REPORT ON THE SEWERAGE AND DRAINAGE
OF THE CITY OF HOBART:

REPORT BY MR. C. NAPIER BELL, M. INST. C.E.

REPORT ON THE SEWERAGE AND DRAINAGE OF THE CITY OF HOBART.

To the Chairman of the Metropolitan Drainage Board.

Section of Intercepting Sewer
Park Creek to One Tree Point—

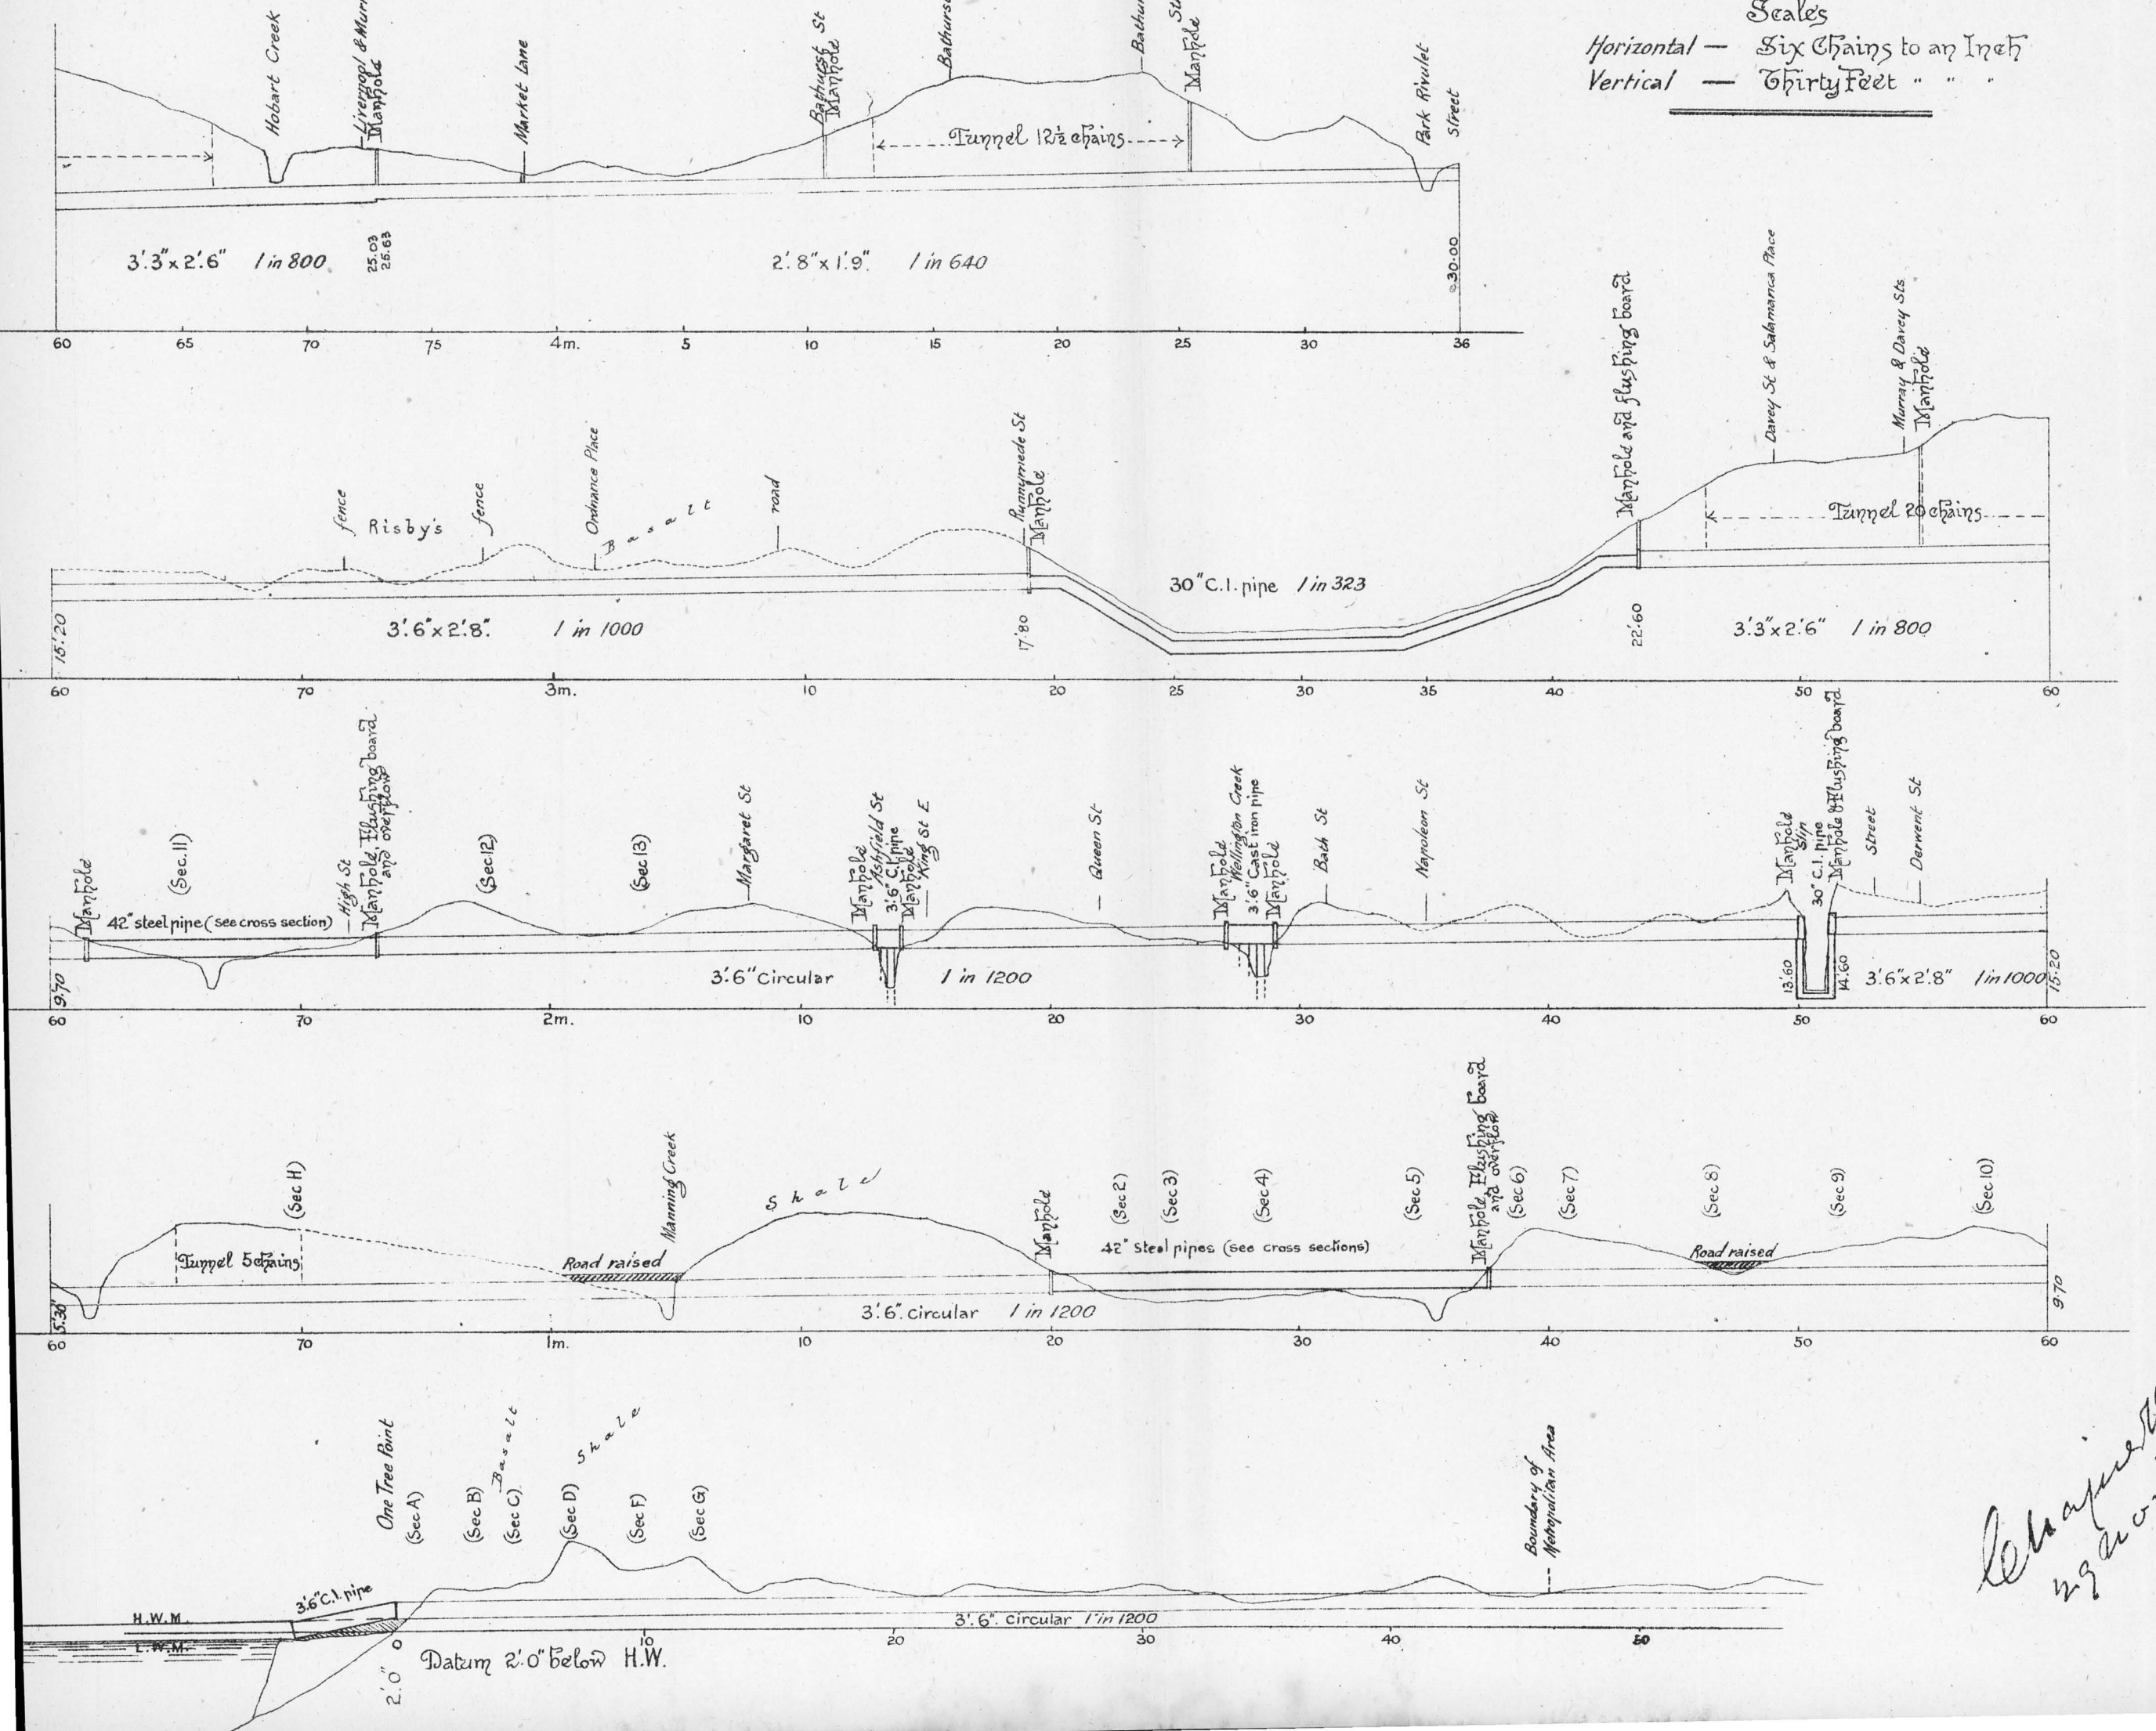
I have accordingly prepared a plan and section of an intercepting sewer, beginning at Park Rivulet, running through the lower part of the town, as shown on plan herewith, skirting the shore round Battery Point, passing through the lower part of Queenborough, and on to the Sandy Bay Road, following this road to Manning's Creek, then passing through lower ground on the brow of the bluffs past the Red Chapel, and on to the low flats, which it follows till it reaches the low bluffs at One-tree Point, skirting round these above high-water level till it reaches the far part of this rocky point, where just under the battery it discharges at high-water mark into the harbour. Plan and Section of it.

The section for this intercepting sewer has correct lengths taken from the plans, and within the city and Queenborough the heights are taken from your Engineer's contour levels; but all along the road the heights are estimated above high water, consequently this part is an approximation, but it will be found fairly correct; a number of sketch cross-sections herewith assist in locating the position, and defining the amount of excavation to be done. I have shown the sewer terminating by a cast-iron pipe about 400 feet out in 12 feet of water; this is a costly termination, which may be modified if 400 feet out is not thought necessary. The extension out into the water is shown standing on an embankment of stone, the pipe and slopes of the embankment being protected from the waves by heavy rock. I would recommend the sewer to be terminated at low-water mark at first, and until it is seen whether there be any necessity to carry it out further. Terminates in deep water.

The flattest gradient for this sewer is 1 in 1200, which is a good gradient for a sewer of the size. The long outlet sewer in Christchurch, of about the same size, has a gradient of 1 in 1760, and has kept clean and free of deposit for 12 years. The sewer discharging at high water can never be tide-locked.

SECTIONS OF OUTLET SEWER AT ONE TREE POINT

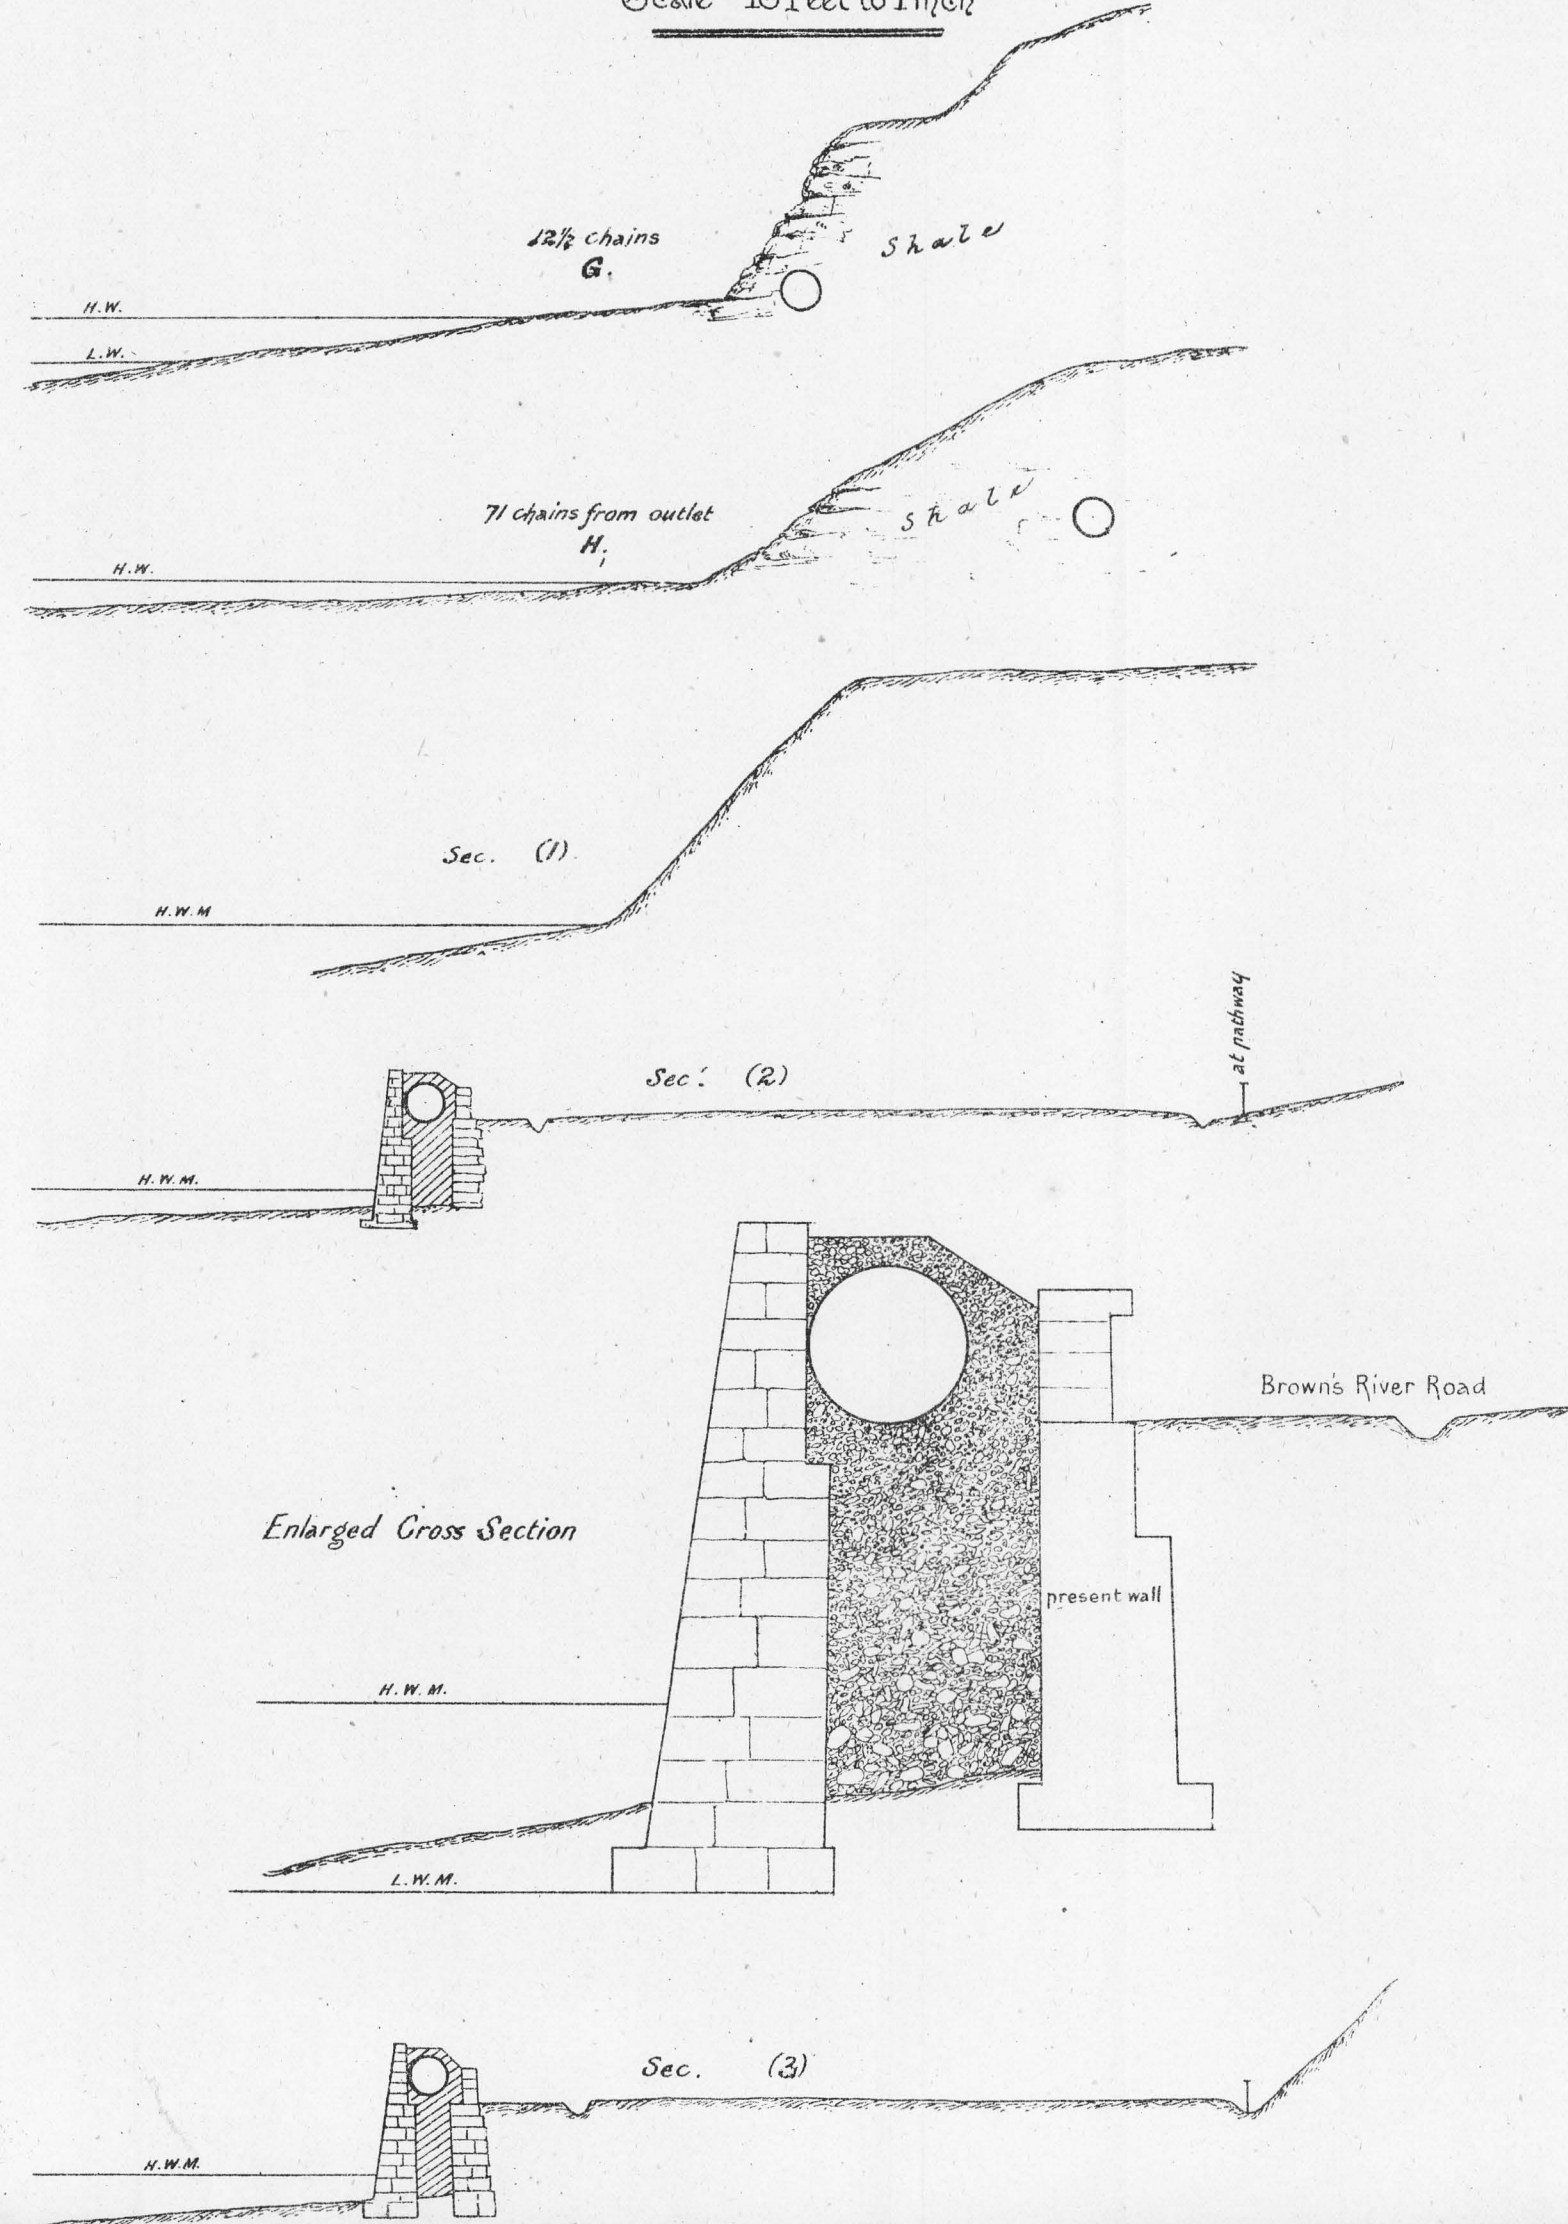
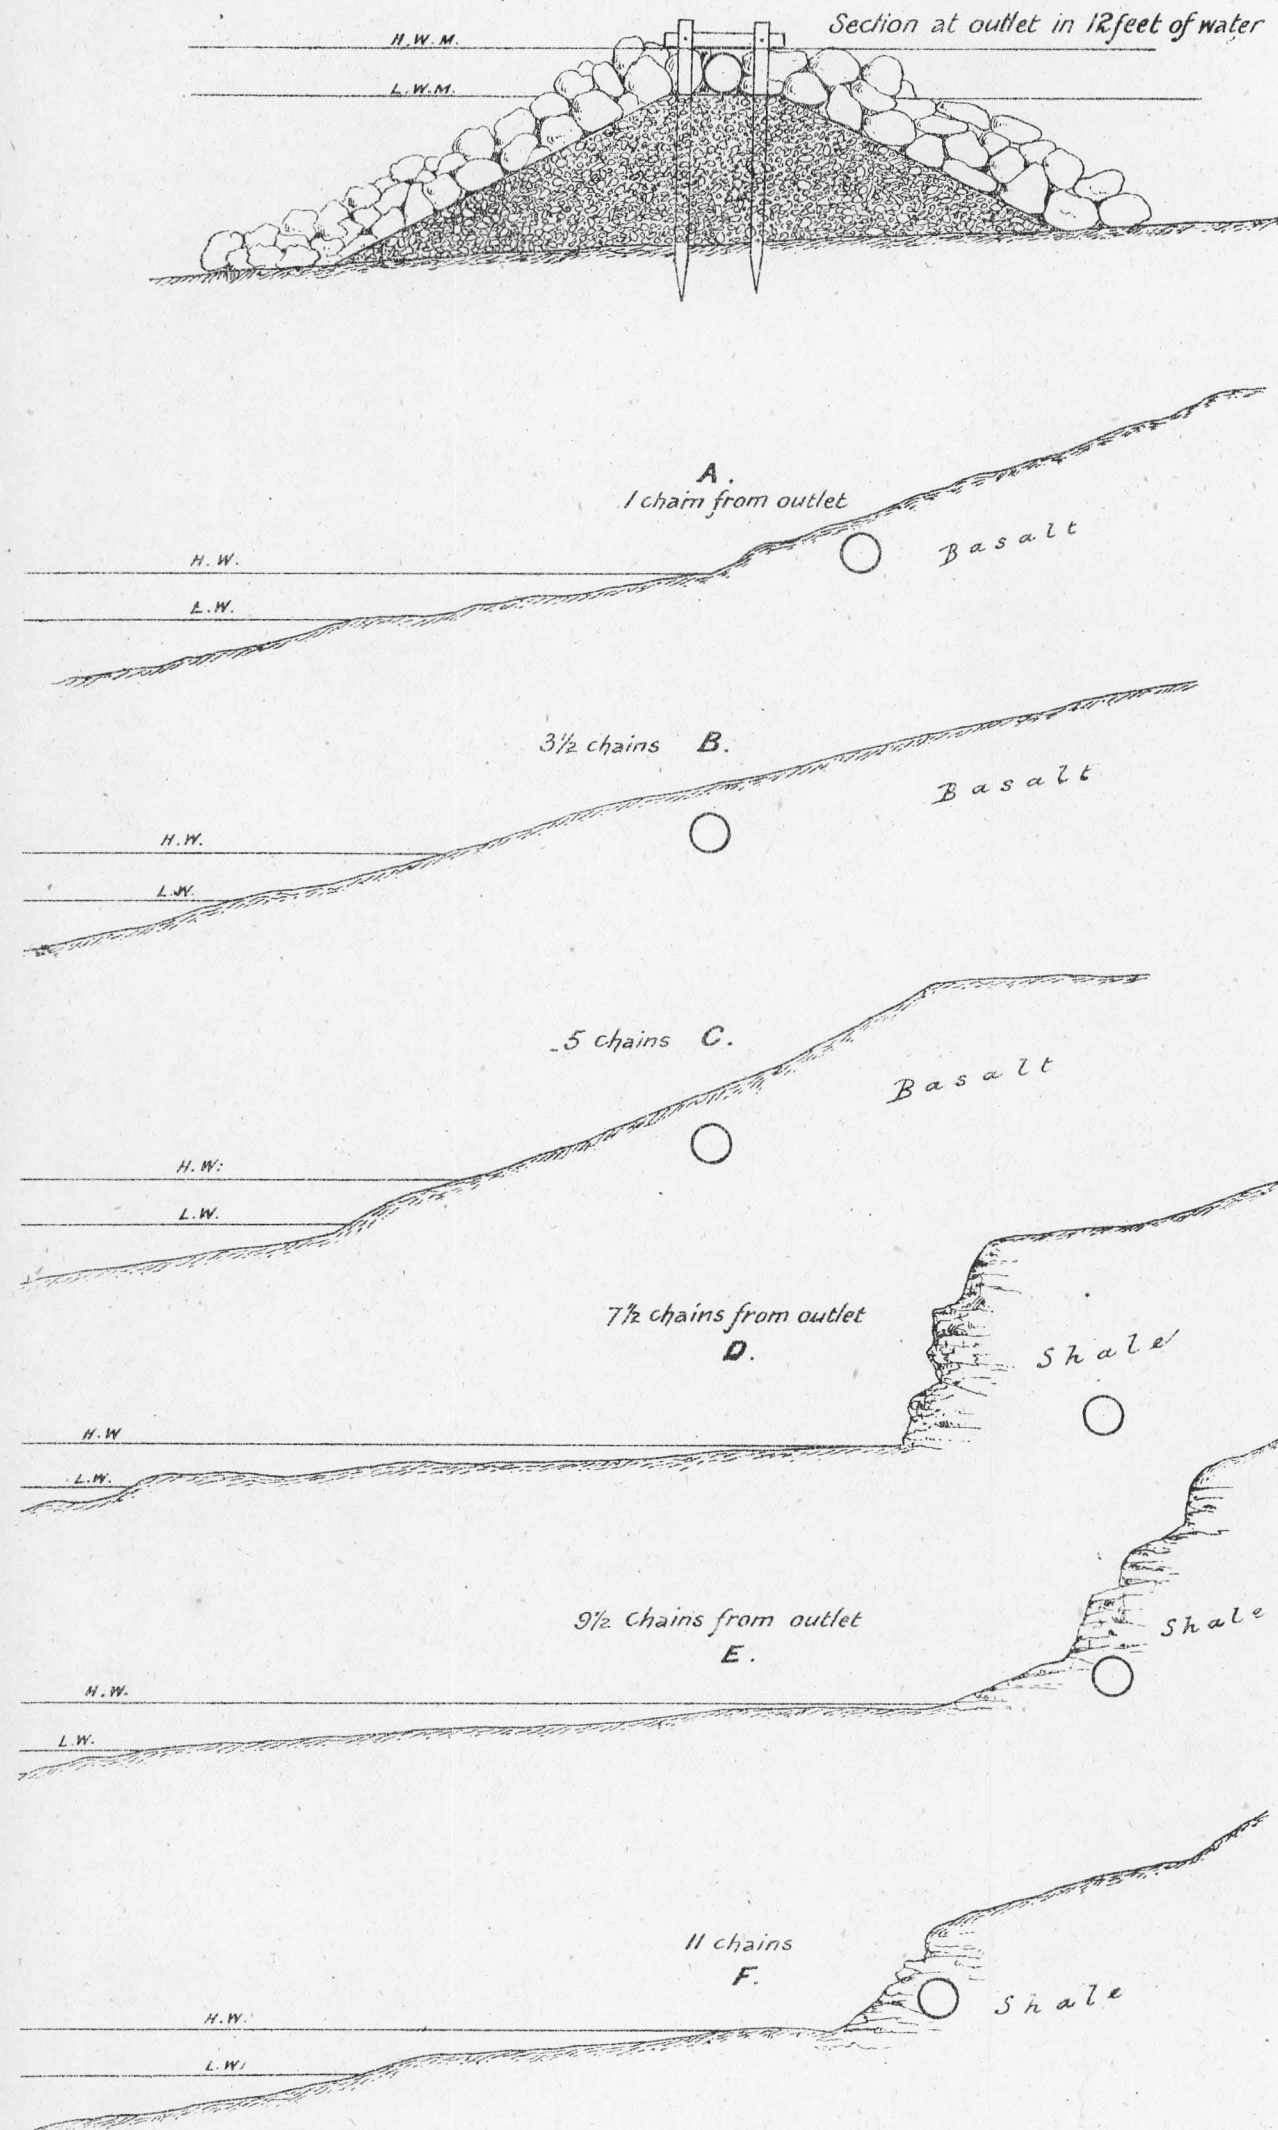
The sewer along the Sandy Bay road crosses two very low parts of the road where the invert of the sewer would be on a level with the road. The method of getting over this difficulty is shown by the sketch cross sections herewith (page 2). The sewage is carried in a steel pipe coated inside and out with asphalt tar; the present retaining wall of the road is to be taken down and rebuilt

outside the pipe and the space being filled with gravel, the pipe will rest on this. The outside wall is to be built as high as the top of the pipe; a small dwarf wall is built on the site of the present retaining wall, and between these walls the pipe is to be covered with earth or gravel; it will thus form a parapet 4 feet 6 inches high above the road, which will serve to keep children from falling into the sea.
